Planning Proposal

1 - 5 Chester Street, Annandale

URBAN DESIGN REPORT

Architectus has been engaged by Inner West Council to undertake a peer review of the Urban Design Study by ae design partnership from May 2019 for the proposal at 1-5 Chester Street, Annandale. Council's objectives for this study are to:

Ground plan showing industrial units with out street frontage
(Extracts from Urban Design Report May 2019 by ae design partnership)

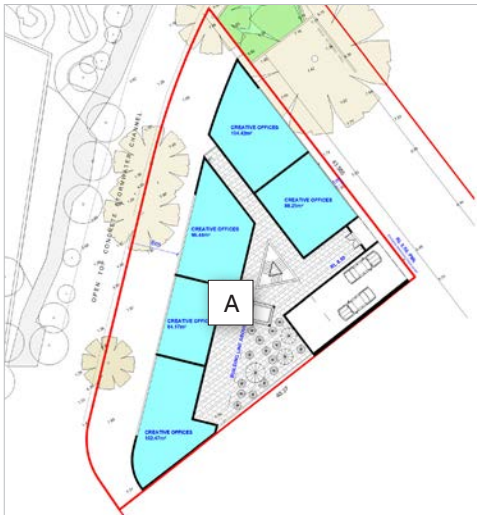
Issue	Appropriateness of May 2019 proposal	Justification	Preliminary recommendation
Land use	<p><u>Urban Design</u></p> <ul style="list-style-type: none">– The proposed typology for a mixed use building is atypical and not considered appropriate.– The proposed industrial uses which are individual 'creative offices' have limited street frontage and appear more as home offices. There is also no large vehicle access to service these uses [A]– Compatibility of residential uses and industrial uses in this form may cause land use conflicts (as described further under Bulk and form).– The boarding house unit sizes (approx min 18sqm) are similar to what is being delivered across Sydney. The amount of communal space is acceptable however no communal open space is not (further discussed in Open Space and Deep soil). <p><u>Planning</u></p> <ul style="list-style-type: none">– The proposed typology for industrial uses would not deliver on the state government and Council's vision for the Camperdown precinct or the objectives for the IN2 Light Industrial zone in LLEP2013.– The proposed boarding house uses align with the PRCUTS recommended land use for the site however not with the proposed timeline.	<p><u>Urban Design</u></p> <ul style="list-style-type: none">– Floorplates should be as flexible as possible to ensure buildings can respond to changes to market demand over time.– Businesses generally require a street frontage and front door.– Industrial floorspace and its ability to function should be protected.– 15-20% of student housing FSR is typically for common areas– SEPP (Affordable and Rental Housing) requires minimum 12sqm for single occupant boarding house. Example of boarding house unit in Sydney is shown below and compared to the proposal [B] <p><u>Planning</u></p> <ul style="list-style-type: none">– The Parramatta Road Corridor Urban Transformation Strategy (PRCUTS) in conjunction with the Greater Sydney Regional Plan and the Eastern Harbour City District Plan underline the importance of the Camperdown Precinct as part of the Camperdown Ultimo Collaboration area with a focus on the biotechnology sector.– While the PRCUTS recommends that the site be zoned R3 Medium Density Residential (with a focus on key workers, affordable housing and student housing), the site is not proposed for residential development until after 2023, as it is outside the boundary of the PRCUTS Implementation Plan for 2016-2023.– The proposed typology would be unlikely to meet the objectives of the IN2 Light Industrial zone in the LLEP2013, such as 'to support and protect industrial land for industrial uses'.	<ul style="list-style-type: none">– Architectus is not opposed to a mix of uses on the site (including residential uses) provided that the site can:<ul style="list-style-type: none">– deliver the employment uses envisioned for the Camperdown Precinct– ensure residential uses are well separated to prevent compatibility issues that would detract from the future employment potential of the precinct.– Architectus is however concerned with the proposed mixed use typology which is atypical. The model should be checked, as from Architectus' experience:<ul style="list-style-type: none">– Industrial uses prefer to have flexible large floorplates and street frontage. A large industrial floorplate also allows residential uses to be well separated.– Council should know that a final design could vary considerably and be satisfied appropriate controls will ensure a high quality boarding house outcome.– Council should seek to be satisfied that the uses proposed are the right typology which can be delivered on the site, achieve the vision for the Camperdown Precinct and provide flexibility to meet future needs.

Section of proposal showing difference in terrain level either side of the creek (Extract from Urban Design Report May 2019 by ae design partnership)

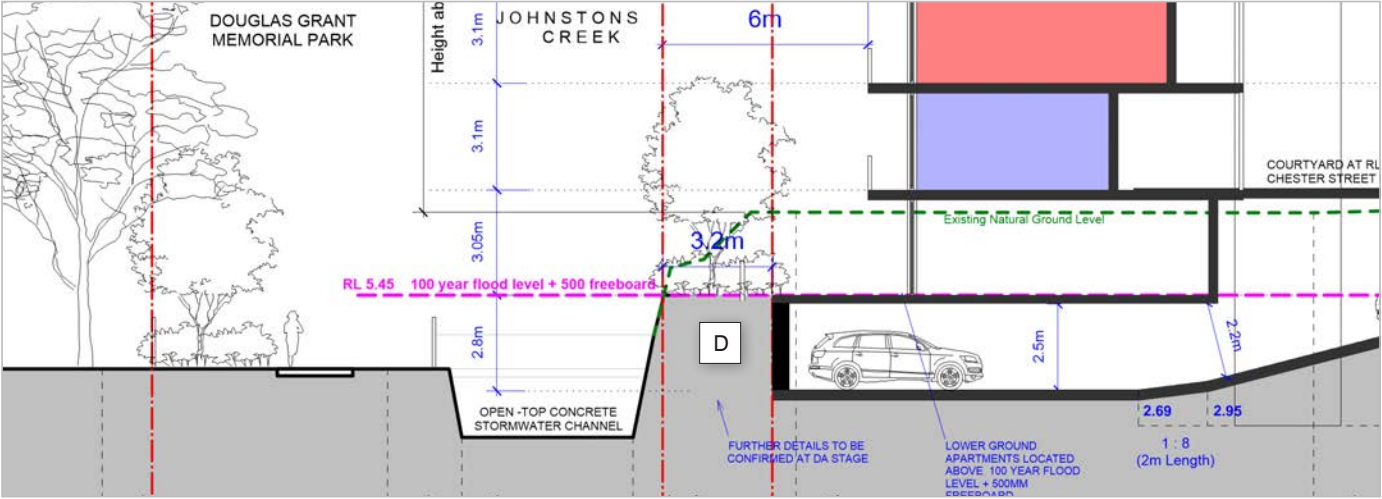
Slope and levels	<ul style="list-style-type: none">– The terrain level on the Johnstons Creek frontage is lifted up to RL 5.45 to be above the 100 year flood level (according to the section), which is approx 2m higher than the terrain level on the opposite side of the creek [D]. This is not appropriate as it results in a poor interface with the creek and the properties west of the creek including Douglas Grant Park.	<ul style="list-style-type: none">– Developments should optimise the interface with the natural environment. By lifting the terrain, the difference in topography either side of the creek is exacerbated. The site feels disconnected from the creek frontage and its neighbours.– Douglas Grant Park is a key local public space and it is important that adjacent properties contribute to providing an attractive frontage to this space with good passive surveillance.– Council's proposed shared path shows the same terrain level either side of the creek [E]– Note: There is an inconsistency in ground heights between the section shown and the render. The render appears lower as the basement carpark is visible [F].	<ul style="list-style-type: none">– The terrain on the Johnstons Creek frontage should be lowered to match the terrain height of the properties and park west of the creek, as per Council's Section of the proposed share path and thus provide a better interface with the creek. Note the basement level of the development needs to be appropriately screened so it doesn't provide a blank wall to this frontage.

The terrain on the Johnstons Creek frontage should be lowered to match the terrain height of the properties and park west of the creek, as per Council's Section of the proposed share path and thus provide a better interface with the creek. Note the basement level of the development needs to be appropriately screened so it doesn't provide a blank wall to this frontage.

Basement plan highlighting tight turn at the bottom of the ramp

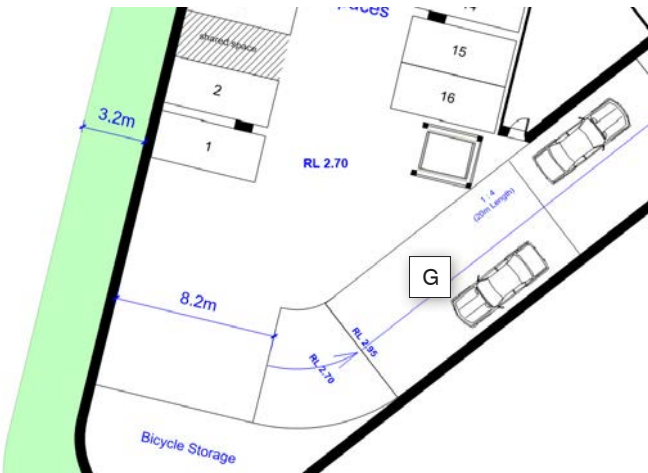
Movement and access	<p><u>Pedestrian</u></p> <ul style="list-style-type: none"> The proposed 'creative office' units should be accessed from the Chester Street frontage as this is the primary frontage for the development. <p><u>Vehicular</u></p> <ul style="list-style-type: none"> The turn at the bottom of the carpark ramp seems very tight and if the carpark is to be setback 6m from the Johnstons Creek frontage that will most likely not work. [G] It is noted, it may be acceptable for the basement to step out into the setback below basement level. The proposal does not provide include truck access. 	<ul style="list-style-type: none"> Industrial uses prefer street frontage and front door. Industrial uses require truck access to site. 	<ul style="list-style-type: none"> The industrial units typology should be reviewed (as described under Land Use) and ensure the industrial uses have a primary frontage and can be accessed from Chester Street. Configuration of carpark should be revised.
